ADDENDUM #4

Date: 2/20/2025

Project: 2025 Roofing Project for the
Merrillville Community School corporation
6701 Delaware Street
Merrillville, Indiana 46410
Architect's Project #24066

SHEET
A
3.2.1

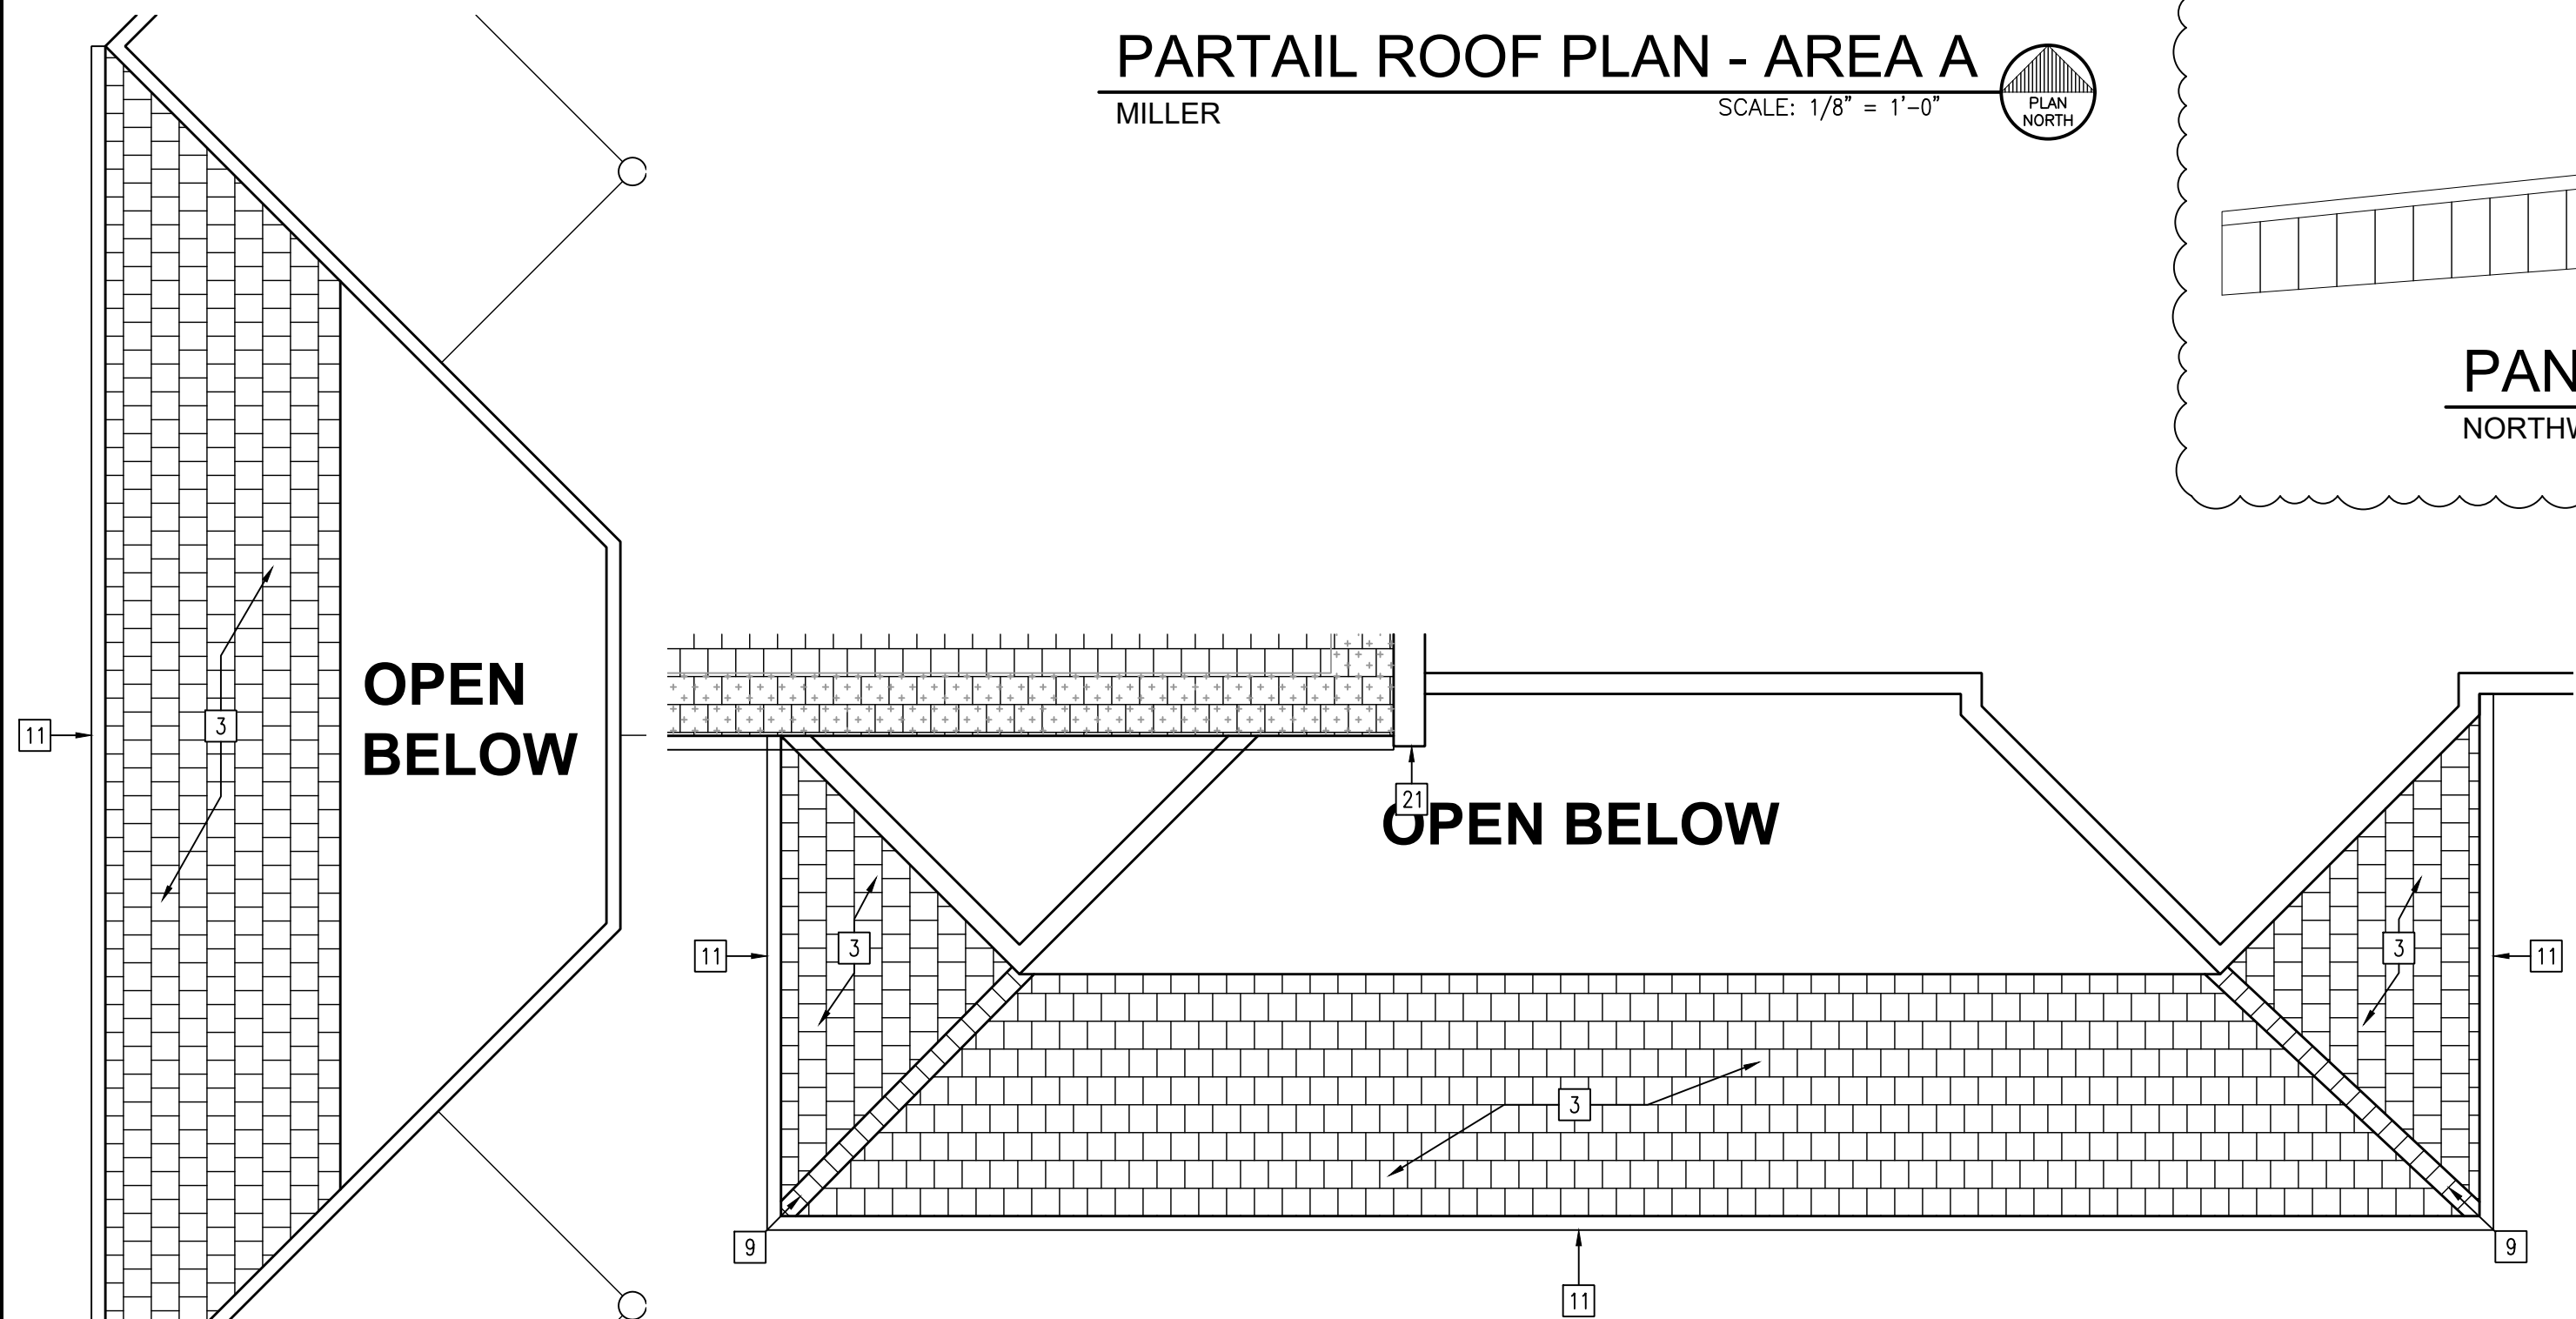
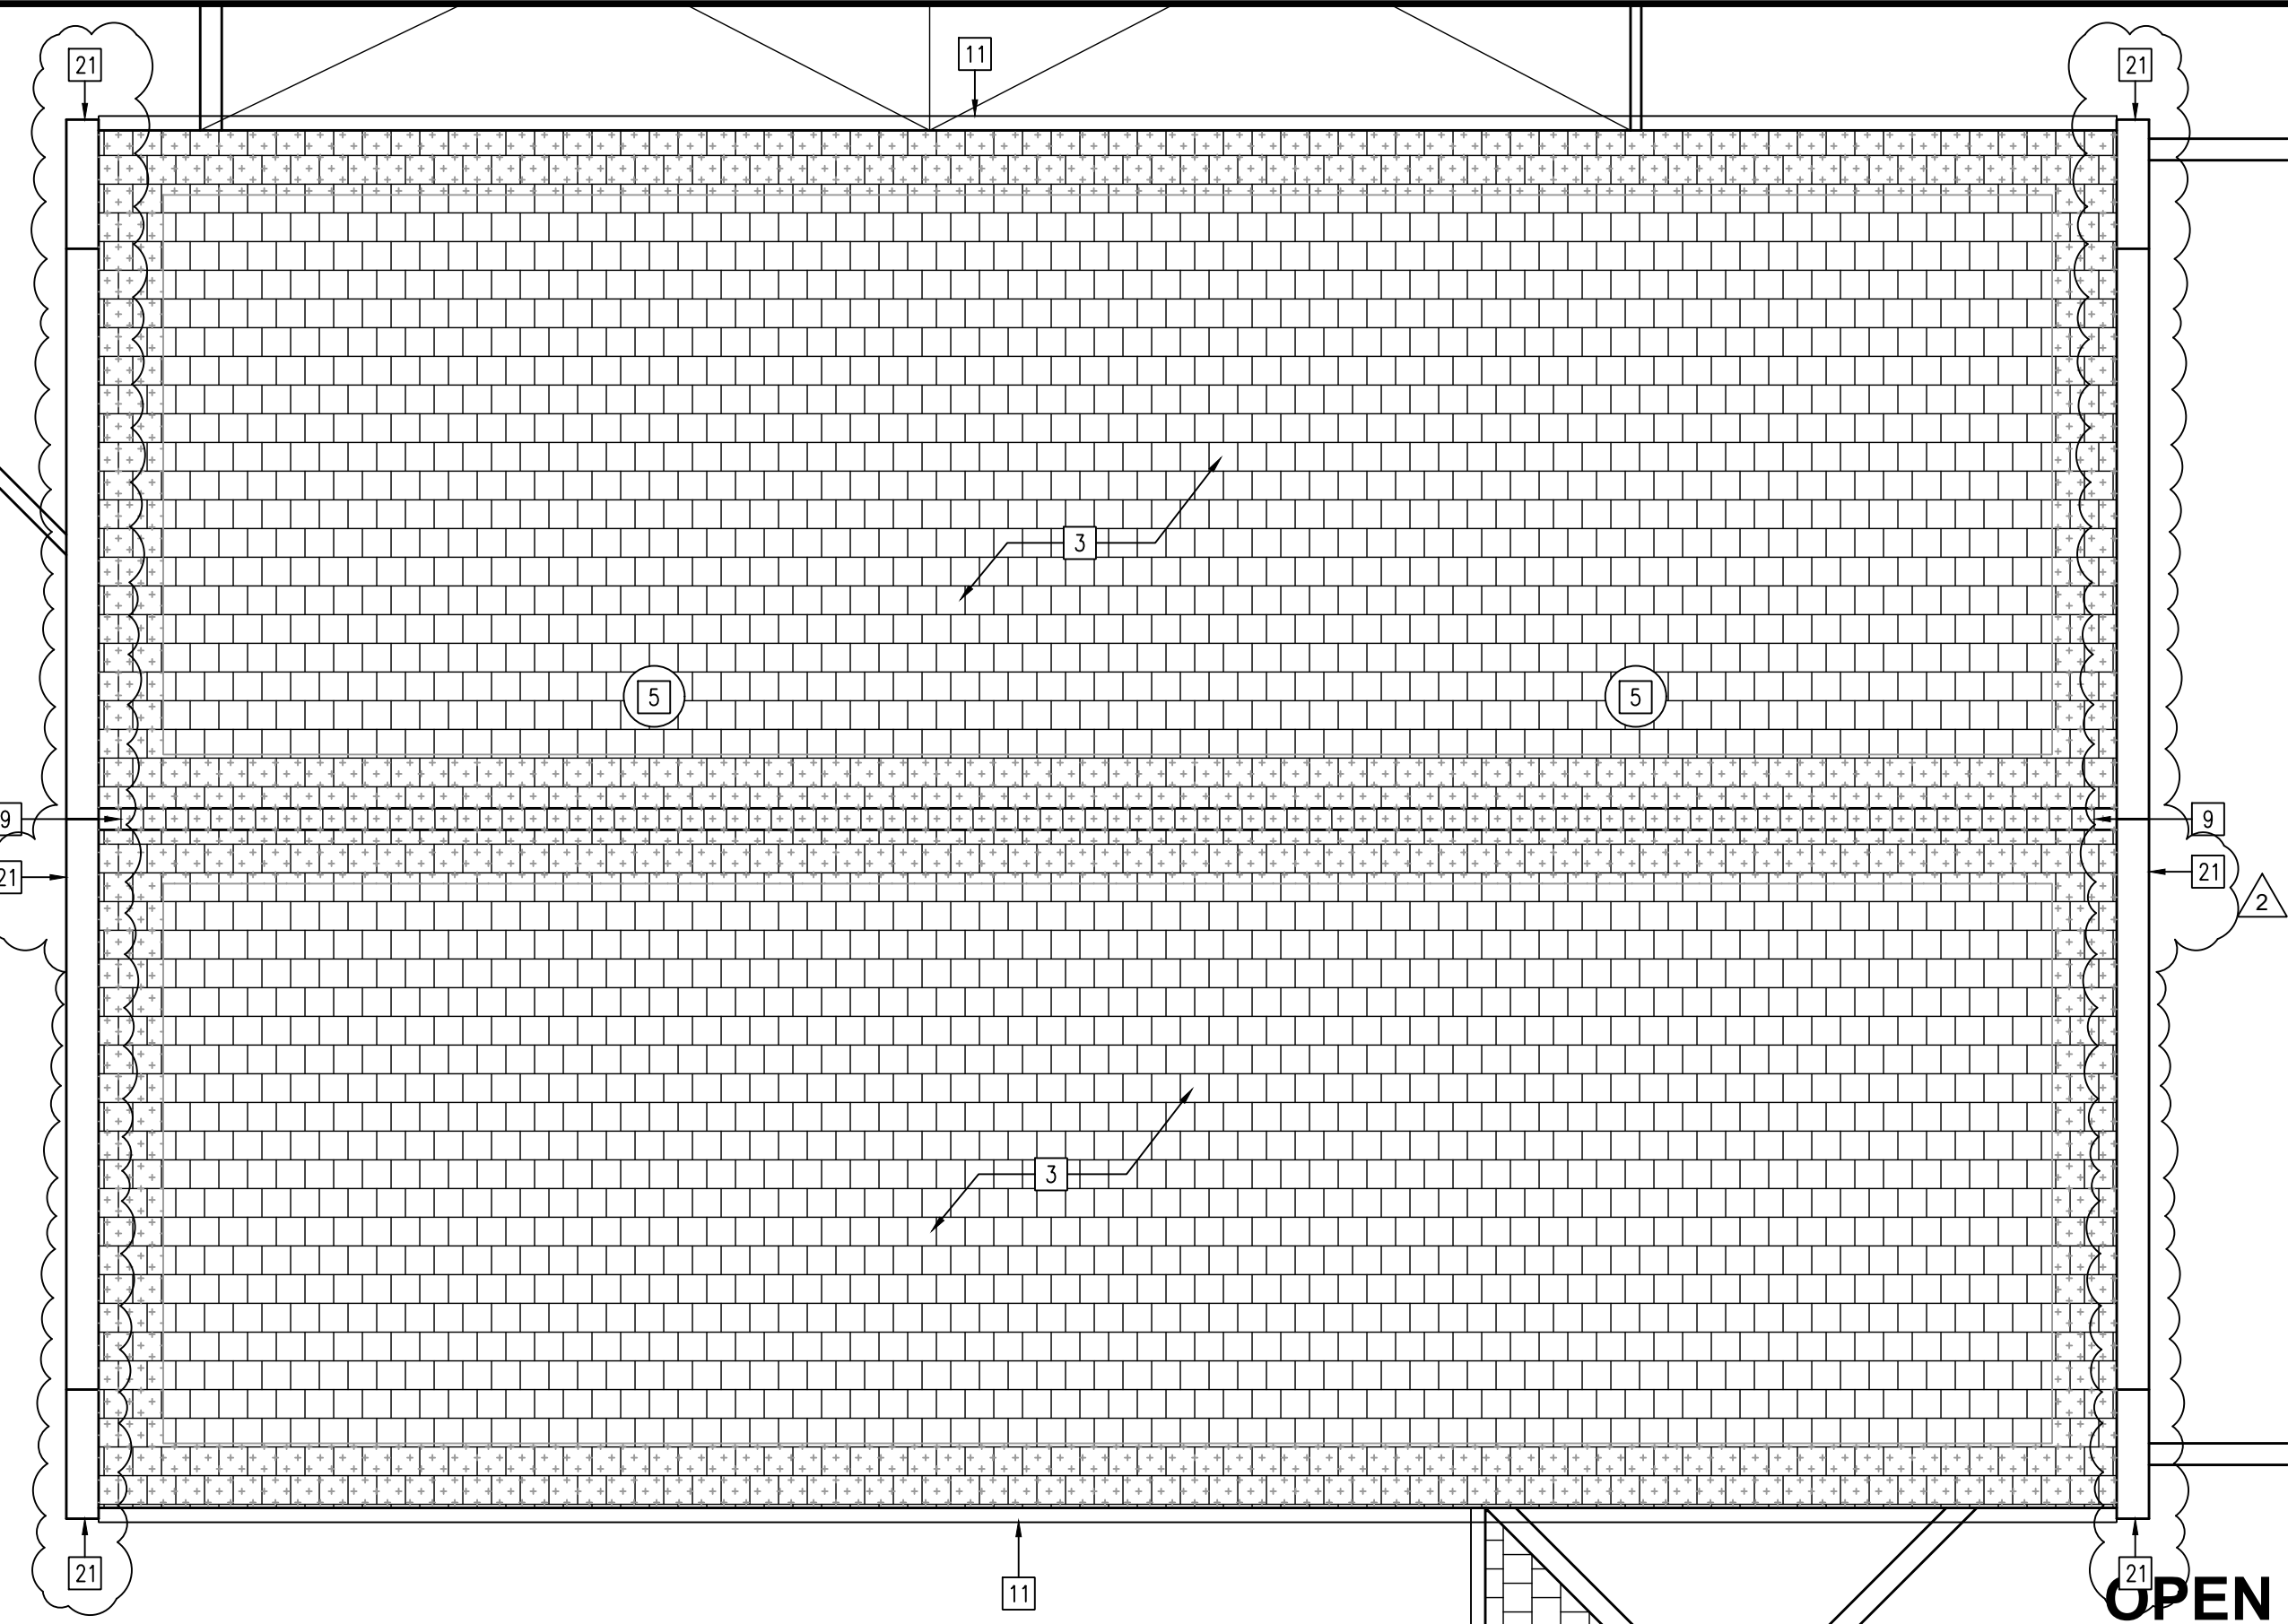
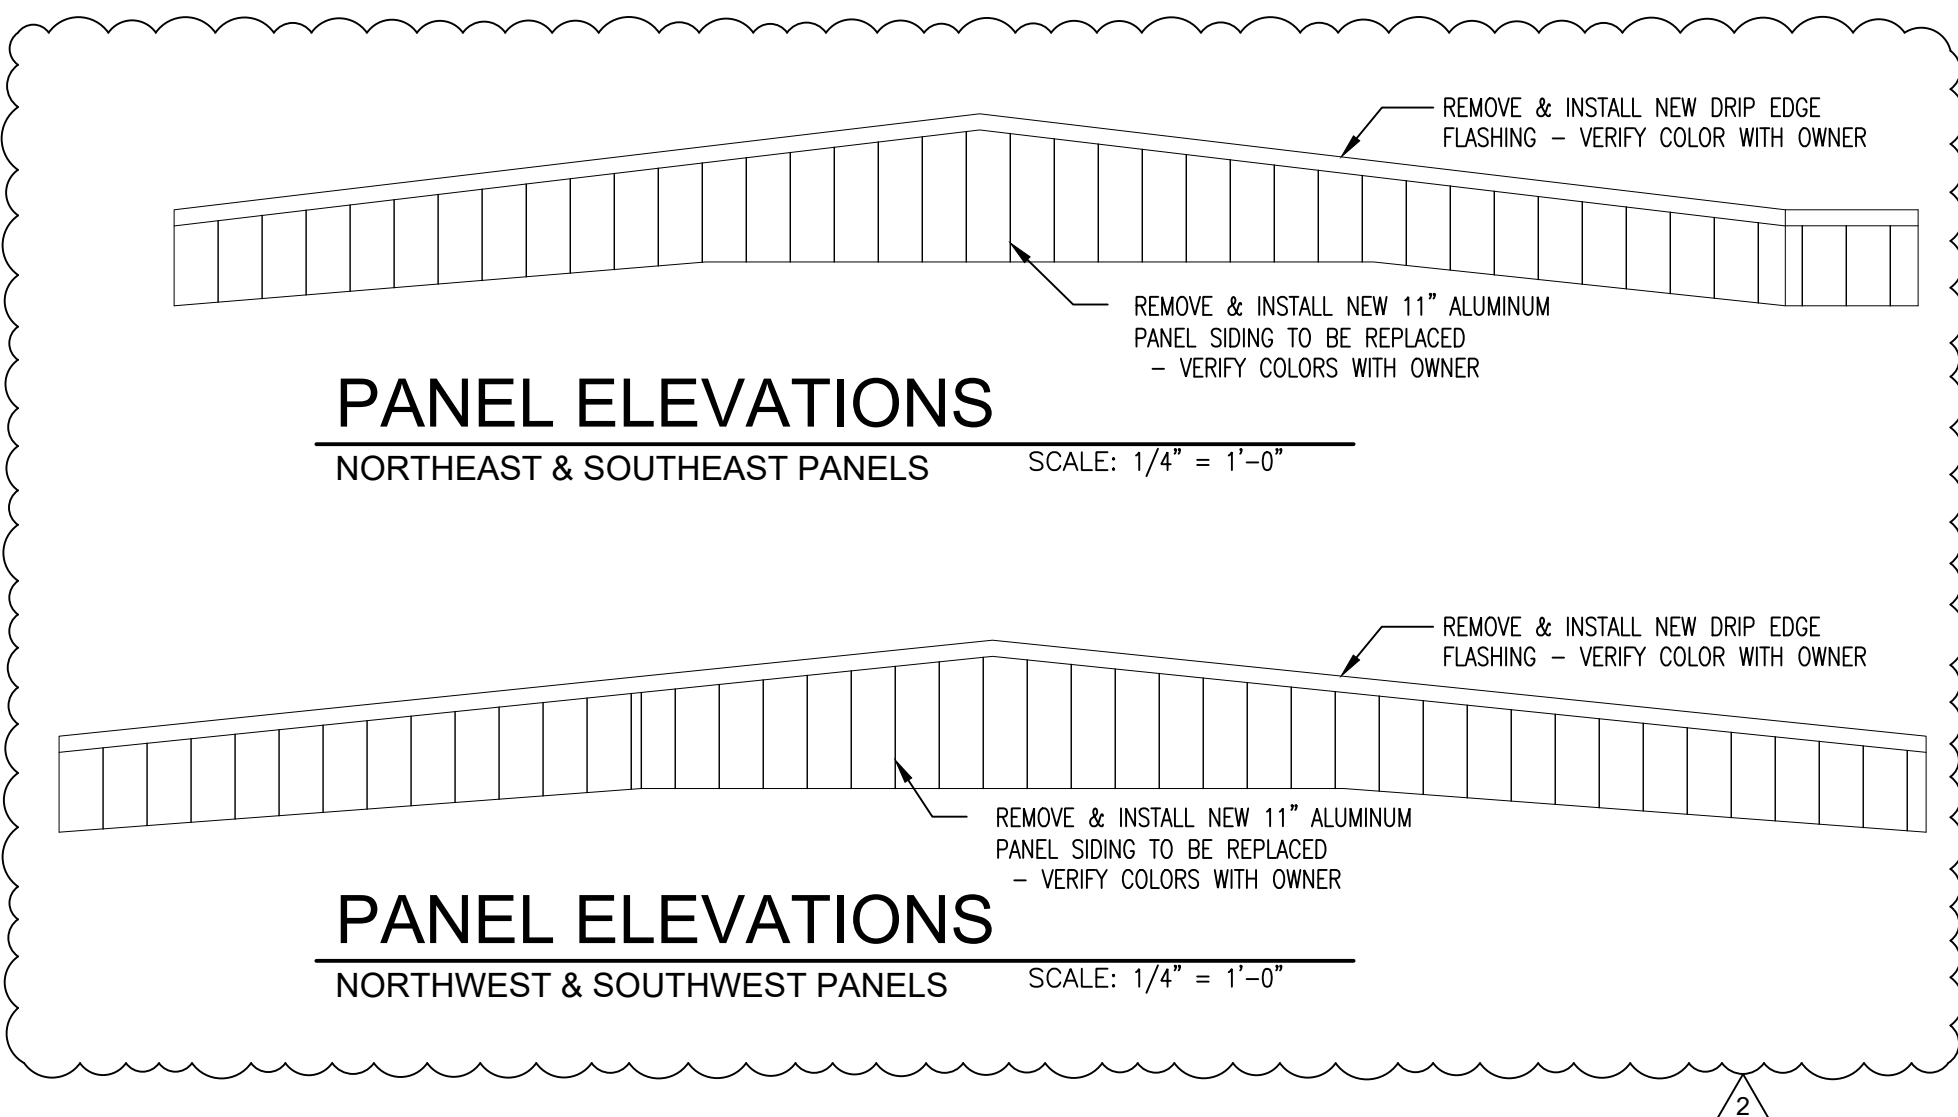
4. See attached Revised Drawing Sheet A 3.2.1 – Partial Roof Plan – Miller - This plan shows clouded and tagged revisions dated 02-20-2025
5. See attached Revised Drawing Sheet A 3.3.1 – Partial Roof Plan – Wood – Area A- This plan shows clouded and tagged revisions dated 02-20-2025
6. See attached Revised Drawing Sheet A 3.3.2 – Partial Roof Plan – Wood - Area B - This plan shows clouded and tagged revisions dated 02-20-2025
